Stephens Co.

SK of Surs, Surrounding
Ruthy Campbell
Also Brown's letter.

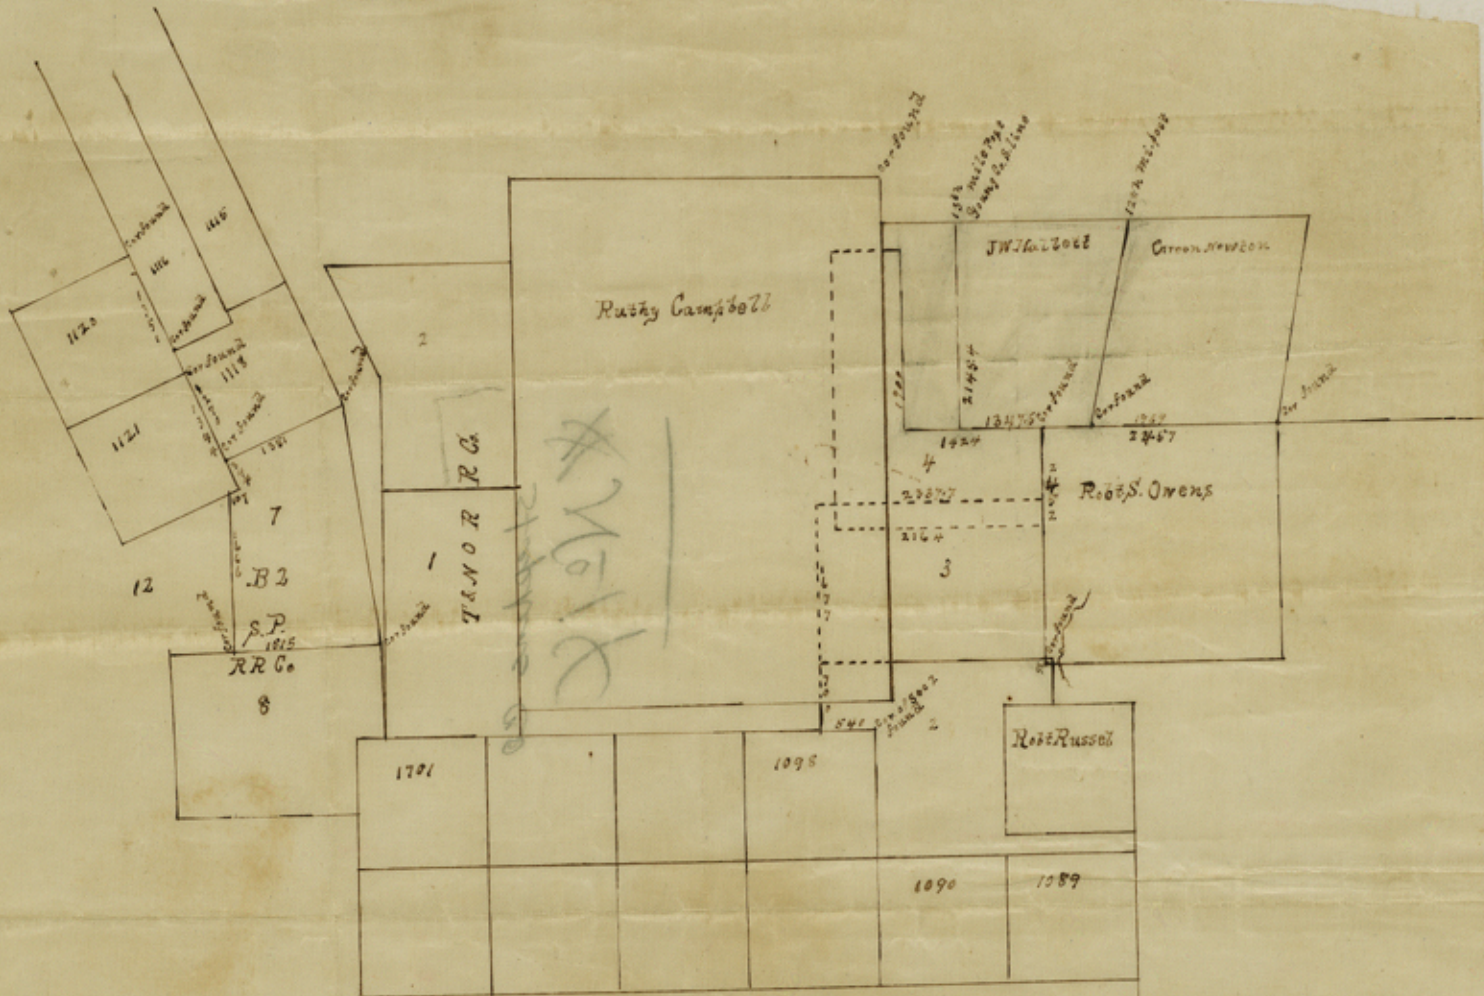
Sir: Replying to yours of the 12th ult; I will state that Surveys Nos. 3 & 4 of S. P. Ry. Co. were corrected, No. 3, August 22, 1874 and No. 4 Aug. 25, 1874. Section No. 4 should be corrected to embrace the space between R. Campbell and J. W. Kallett, but the latter survey will hold the 1900 rods called for on its South line, and the West line should be made to run parallel to the East line. No. 3, being a patented survey, will be entitled to the full width of 1677 rods.
